Procurement Department  
IFB: Dining Hall Serving Area Renovation  
Project SU-061224  
Addendum #01 \* August 23, 2024

Purchase College Project #SU-061224  
Dining Hall Serving Area Rehab

**Addendum #01 – Bidder's Questions & Answers**

**1 TYPE 1 - TYPICAL INTERIOR PARTITION**

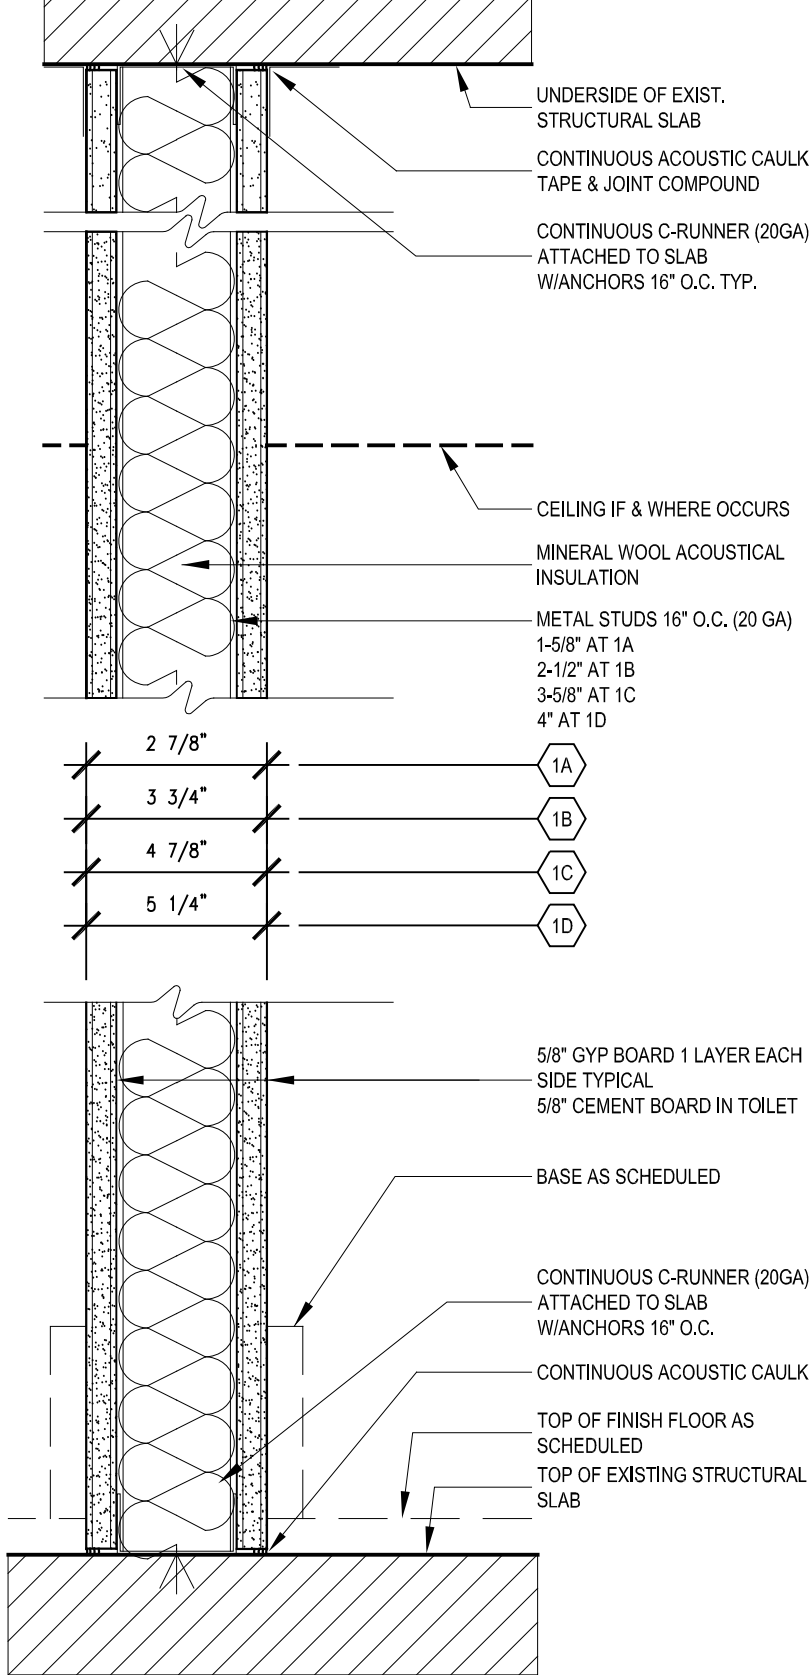
- Q4. The drawings on page A-200 indicate a 1C wall partition in the top right corner. However, there is no 1C partition detail on page A-400. Could you please confirm if this partition should be 3C instead?

- A4. The 1C partition symbol is correct. It is our understanding that there will be an existing opening which will need to be filled in. The detail for 1C partition type is attached.**
